service bulletin

M81-26

SUBJECT: PRESSURIZATION OF MAGNETOS IN MOONEY M20K AIRCRAFT

AFFECTED: TSIO-360GB Spec. 1 & 3 Engines.

FIGURE 1

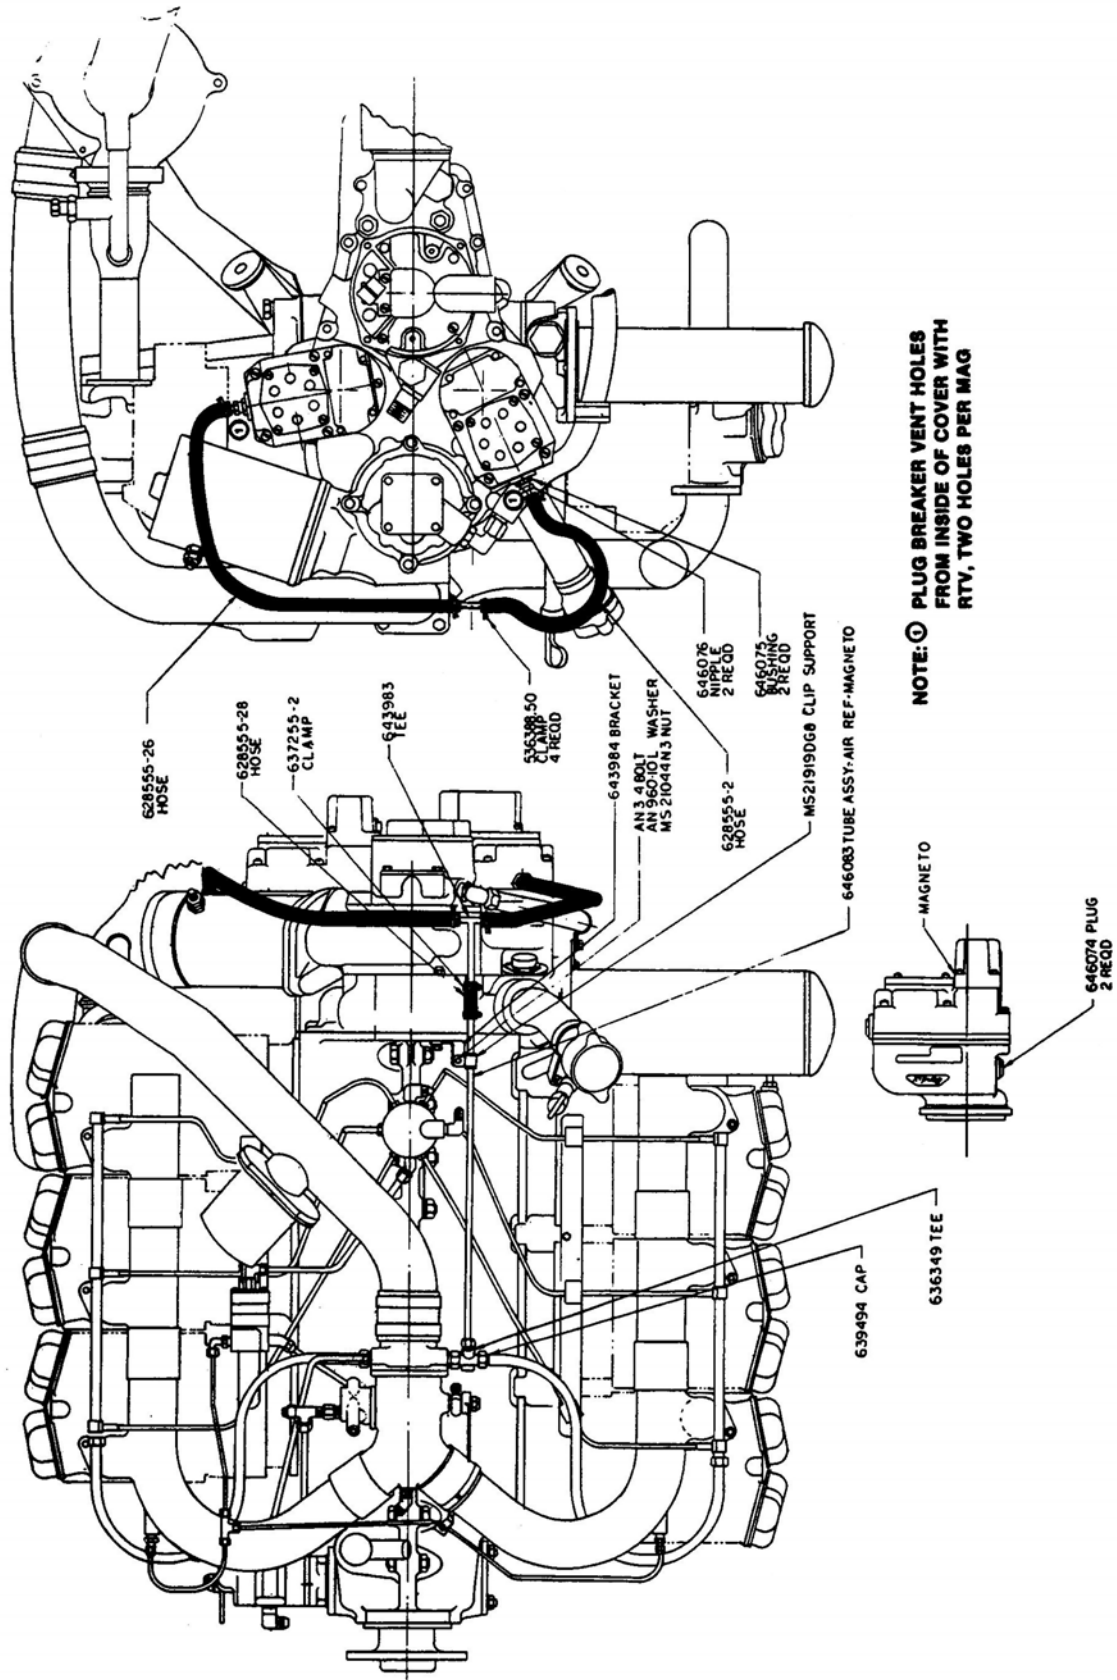
For improved altitude performance, we recommend that owners of TSIO-360GB engines equipped with Bendix S6RN-20 magnetos install the pressurization kit EQ6565 in accordance with Figure 1.

Bendix Service Bulletin 612 should also be complied with at this time.

FIGURE 2

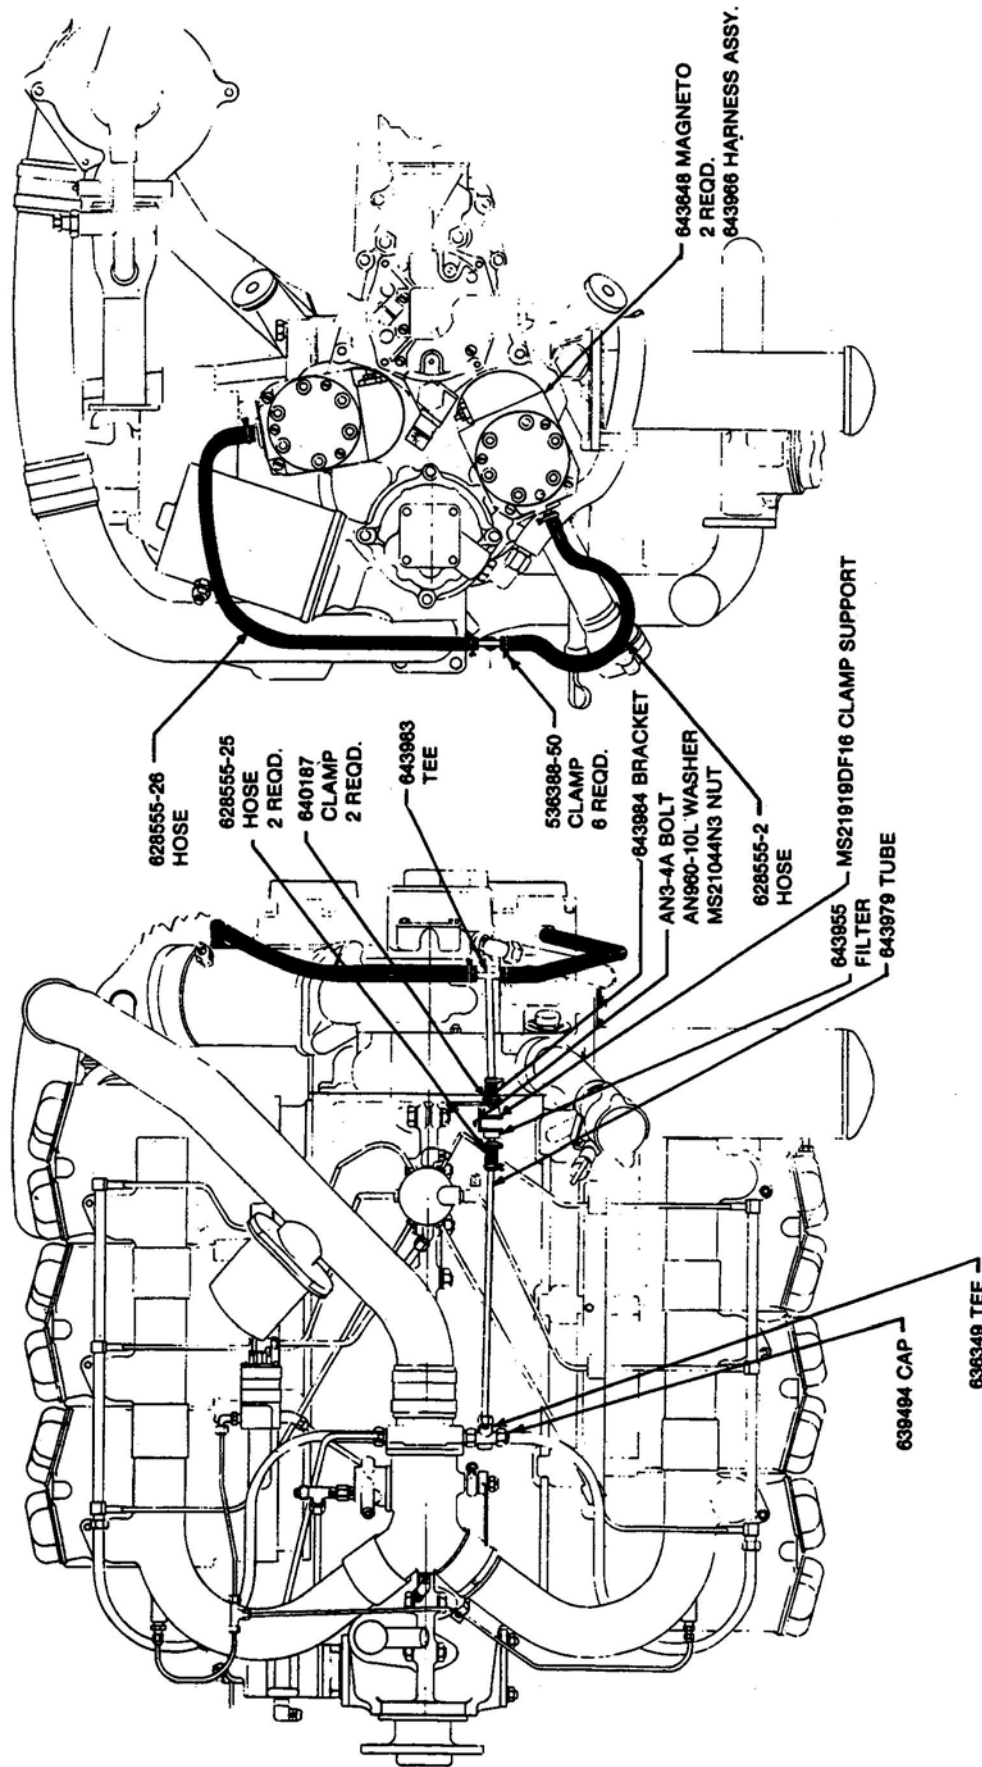
Installations with Slick Magnetos can be pressurized using kit EQ6569 in accordance with Figure 2. Reset timing in accordance with instructions in Overhaul Manual form X30030A.
